**STAFF REPORT**

**CASE NUMBER:** P. D. 09-321                      **L.U.C.B. MEETING:** October 8, 2009  
*Held from September 10, 2009*

**DEVELOPMENT NAME:** BUILDERS' EXCHANGE PLANNED DEVELOPMENT

**REQUEST:** Planned development to combine two(2) adjacent parcels to allow additional parking at the east side of the building

**OUTLINE PLAN:**

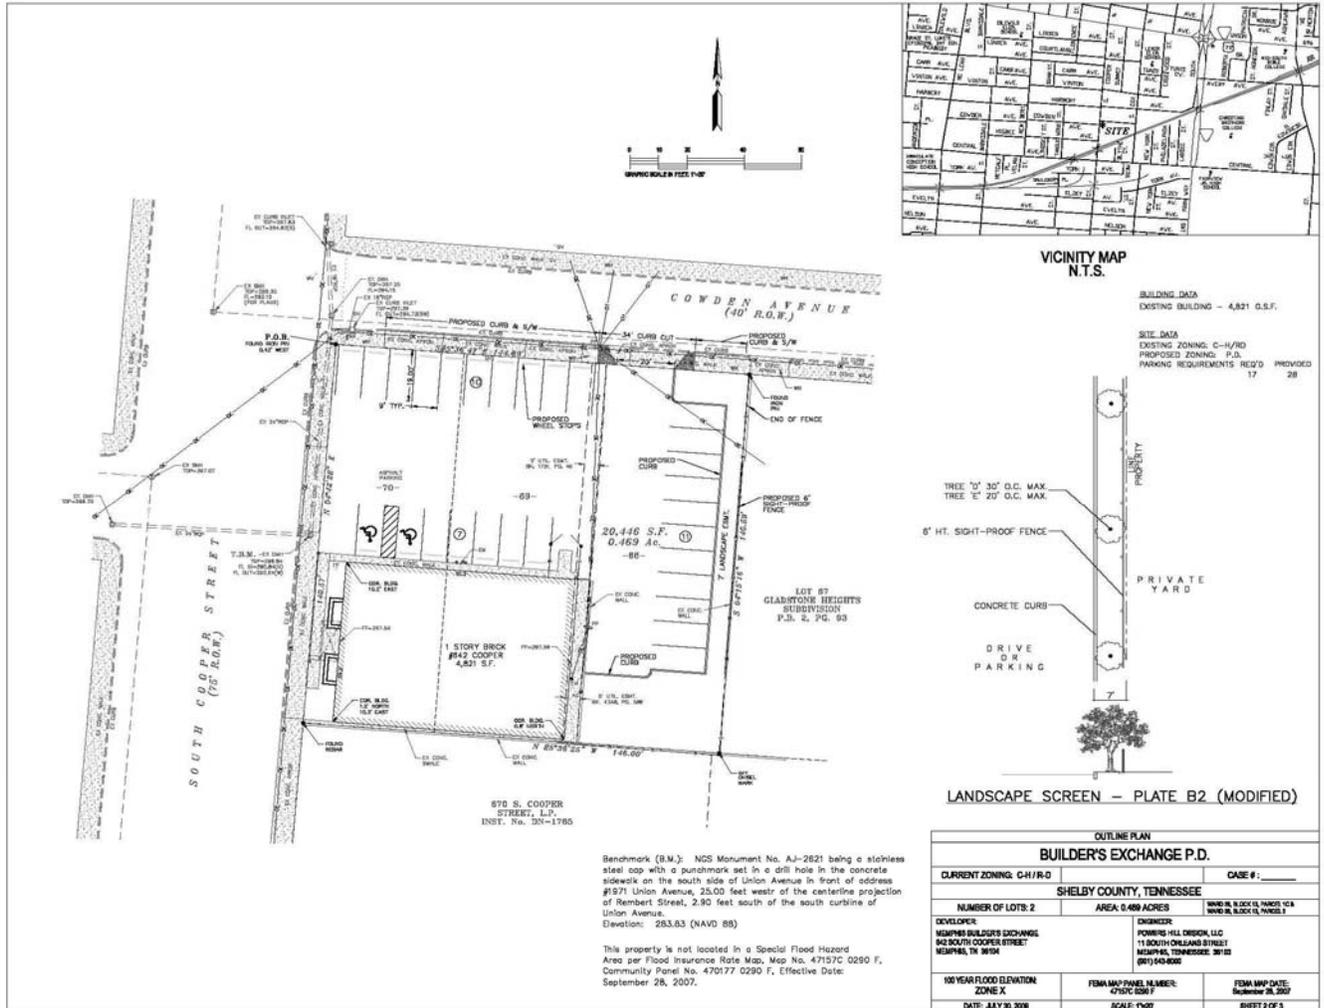
- 5. The Outline Plan illustrates a parking layout design with parking up to the street along South Cooper and Cowden Avenue. The parking spaces at the intersection shall be eliminated to provide a landscape treatment at South Cooper Street and Cowden Avenue. The parking should also be pulled back from the street with new landscape treatments along the streets.**

The office building currently has eighteen(18) parking spaces with two(2) curb-cuts to Cowden Avenue and the vacant lot has a residential curb-cut that will meet commercial standards. The total parking would increase by ten(10) parking spaces, including required handicap spaces. The new parking provides eleven(11) spaces along the east property line adjacent to a single family home. A landscape screen seven(7) feet in width will be provided along this property line, including a sight-proof fence six(6') feet in height. However a new sight-proof wood fence already exists on the residential property. The Outline Plan illustrates a parking layout design with parking up to the street along South Cooper and Cowden Avenue. The parking spaces at the intersection shall be eliminated to provide a landscape treatment at South Cooper Street and Cowden Avenue. The parking should also be pulled back from the street with new landscape treatments along the streets to provide better streetscapes at a secondary entrance to a residential neighborhood.

- B. The existing curb cut on South Cooper Street shall be relocated to line up with the proposed center drive aisle and shall be constructed to meet ADA cross slope requirements

- E. The parking spaces at the intersection shall be eliminated to provide a landscape treatment at the corner of South Cooper Street and Cowden Avenue.

6. The proposed curb cut onto Cowden Avenue will have to be relocated approximately 7 feet east of the existing power pole, or the pole will have to be relocated.

7. The two existing curb cuts on Cowden Avenue nearest the intersection shall be closed with curb, gutter and sidewalk.
8. The developer shall construct 6 foot wide sidewalks against the face of curb on all street frontages, as necessary.
